TO: Mercedes-Benz Dealer Principals, General Managers, Sales Managers, Service Managers, Parts Managers	FROM: Gregory Gunther, Department Manager, Vehicle Compliance and Analysis, Engineering Services
RE: Recall Campaign Launch Notification Check Ground and Potential Equalization Connections MY22 EQS-Class (297 platform)	DATE: April 8, 2022

Check Ground and Potential Equalization Connections

Recall Campaign Bulletin

Check threaded connection of ground points on front left longitudinal member, correct if necessary

Figure 1

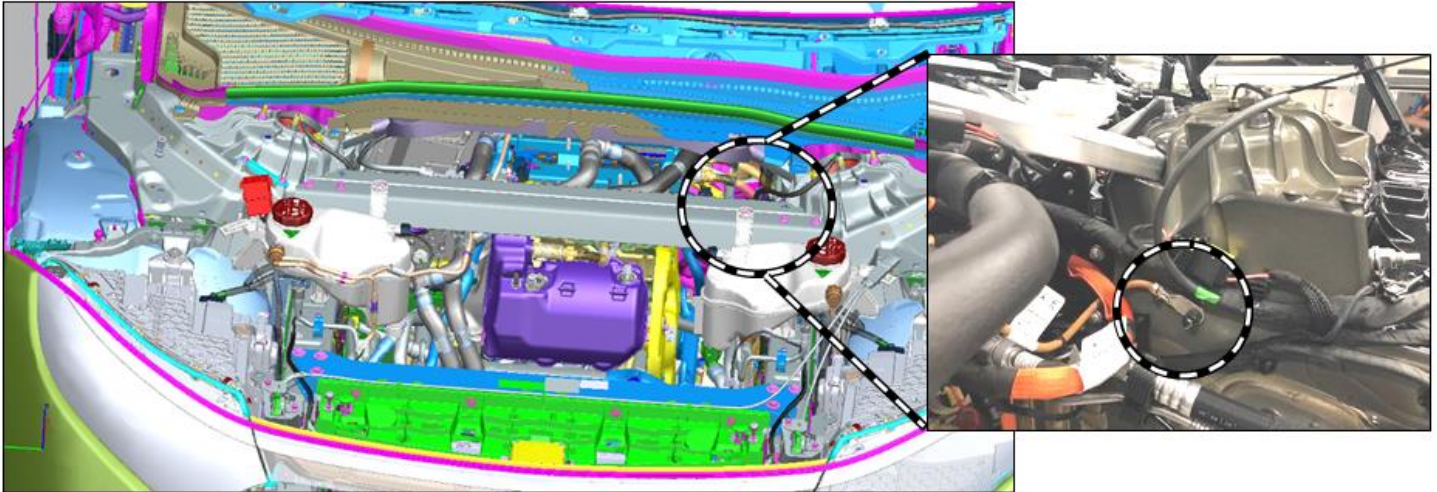
3. Loosen the threaded connection of ground point "W92w2" of equipotential bonding line of high-voltage PTC heater (N33/14) for vehicle interior in area of inner front left longitudinal member and left spring dome and screw on correctly (**figure 1**).

It is possible that the torque of the threaded connection may not have been tightened correctly and this could cause the threaded connection to loosen!

When tightening the ground point "W92w2" of the equipotential bonding line, make sure that the contact surface of the threaded connection is clean and correct!

Threaded connection of equipotential bonding line for the vehicle interior front left longitudinal member high-voltage PTC heater  7!

Figure 2

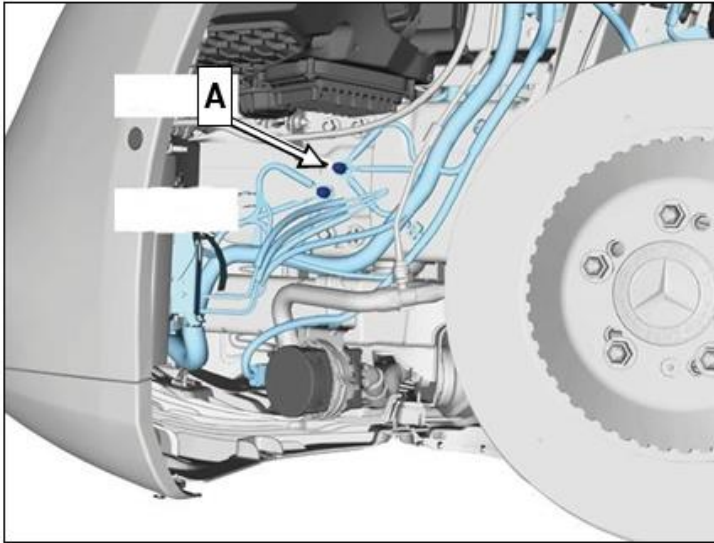
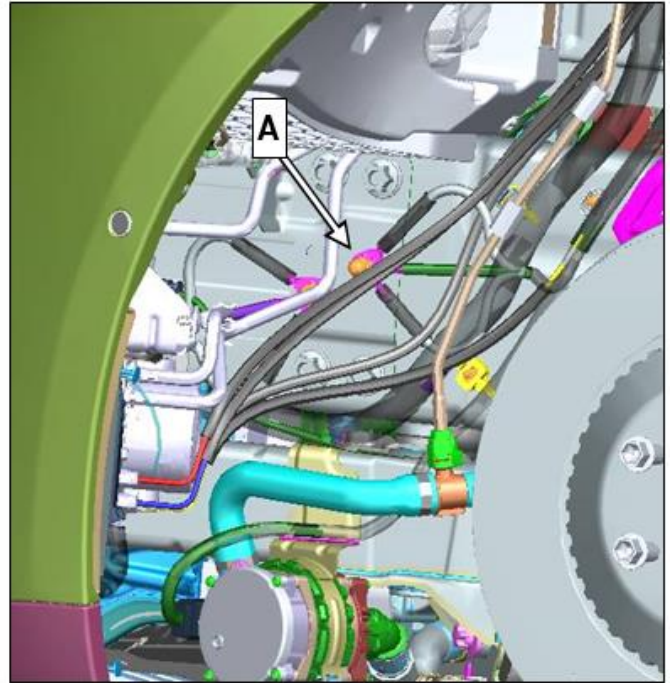
6. Check whether the threaded connection (**A, figure 2 and 3**) of the ground point "W52/8" has been installed correctly on the outer front left longitudinal member.

i It is possible that the threaded connection may be loose!

i The area of the threaded connection shall also be checked for traces of signs of electrical arcing or sparks!

- a. **Arc/spark traces** on threaded connections for ground point "W52/8" **present**: **Perform work procedures A and B.**
- b. **Arc/spark traces** on threaded connections for ground point "W52/8" **not present**: **Perform work procedure B**

1. Remove ground line of ground point "W52/8".
2. Eliminate traces of arcing/sparks on the ground point "W52/8".
 - i** Replace cable lug of ground line, to do this, see basic data under **AR00.19-P-0100A**.
 - i** The corresponding cable lugs shall be determined according to the diameter of the diameter of the ground line!
3. Install ground line of ground point "W52/8".

1. Correct torque of threaded connections of ground point "W52/8".
 - i** Threaded connection of ground point "W52/8" outer front left longitudinal member **Hm** 7!
2. Assemble in reverse order.
3. Perform commissioning of the high-voltage on-board electrical system.
 - i** For basic data, see **AR47.70-P-1000EQS**.
